Date: 27 April 2022
Contact: Nathan Seiler
Location: City Development
Telephone: 07 5582 8866
Your reference:
Our reference: COM/2022/61

Information Request

in relation to development of land/premises described as:
Lot 334 SP193431, Lot 37 SP222486, Lot 6 SP274108, Lot 900 SP316137 – 84-160 Christensen
Road South, STAPYLTON QLD 4207

GENERAL – TRUNK SEWER CONCEPT

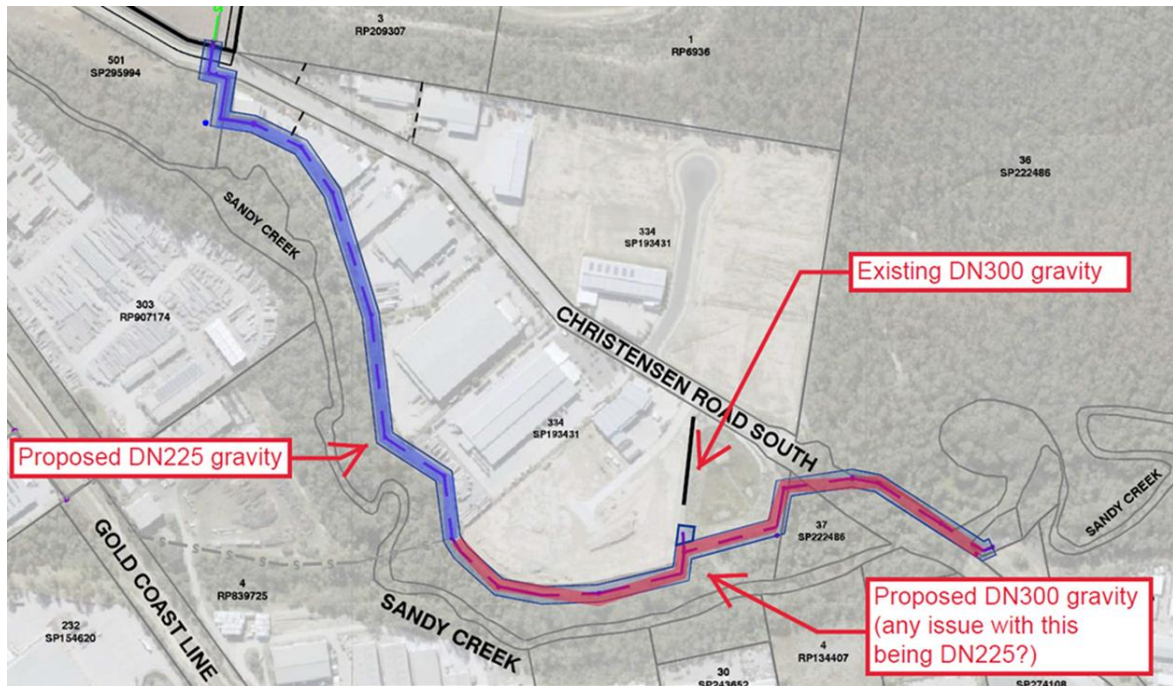
As part of this Minor Change submission, investigate the possibility of simplifying the current alignment (shown on drawings “Sewer Layout Plan Sheet 2 of 5”, 5941 ENG SNA2 601, Revision A, dated 20/11/2021 and “Sewer Layout Plan Sheet 1 of 5”, 5941 ENG SNA2 600, Revision A, dated 20/11/2021, both prepared by Gassman Development Perspectives) from structure 6/S1 to 1/S1 through Lot 37 SP222486 and Christensen Road South road reserve to:

- i) Minimise the number of changes of direction and structures
 - ii) Reduce the overall length of new sewer main
 - iii) Reduce the length of new sewer main crossing under the future road pavement for Christensen Road South.
- c. Amended DA Form 1 for application COM/2022/61 to include all lots within the application through which the proposed trunk gravity sewer is proposed to traverse (including Sandy Creek crossing as mentioned above).
